DISCUSSION

Adjacent box-beam bridges

The following comments relate to “Simplified Transverse Post-tensioning Construction and Maintenance of Adjacent Box Girders,”¹ by Jenna Hansen, Kromel Hanna, and Maher K. Tadros, and “Transverse Post-tensioning Arrangement for Side-by-Side Box-Beam Bridges,”² by Nabil F. Grace, Elin A. Jensen, and Mena R. Bebawy, both of which were published in the Spring 2012 issue of *PCI Journal*.

Figure 1. Comparison of proposed methods with other specifications.
 Note: PCI BDM = *PCI Bridge Design Manual*.

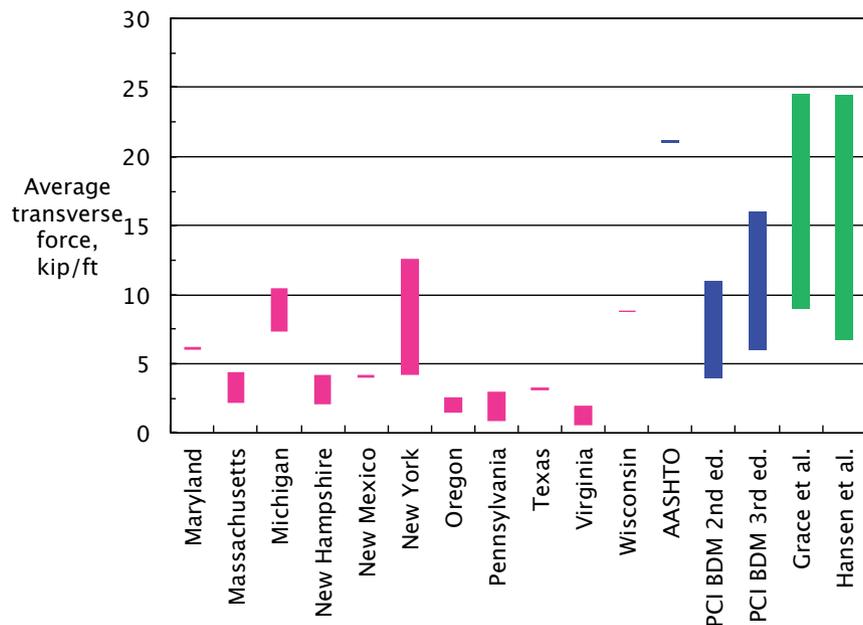
Figure 1 compares the range of transverse forces using the proposed design procedures in each paper with those reported in the second reference listed above. The Grace et al. data are based on spans from 50 to 124 ft (15 to 37.8 m) with widths from 25 to 90 ft (7.6 to 27 m), a newly constructed slab, and the recommended number of diaphragms. The Hansen et al. data are based on Fig. 3 of their paper. Clearly the

range of posttensioning forces is similar for both methods but is much higher than used by most state departments of transportation.

The authors agree that the recommended transverse posttensioning force from the design charts provided in the paper is significantly greater than the current state of practice.

Furthermore, it is important to highlight that the design charts in this paper were developed for southeast Michigan conditions by including the effects of both thermal and traffic loading. The environmental conditions at the bridge location should, therefore, be considered when determining the appropriate level for transverse posttensioning force.
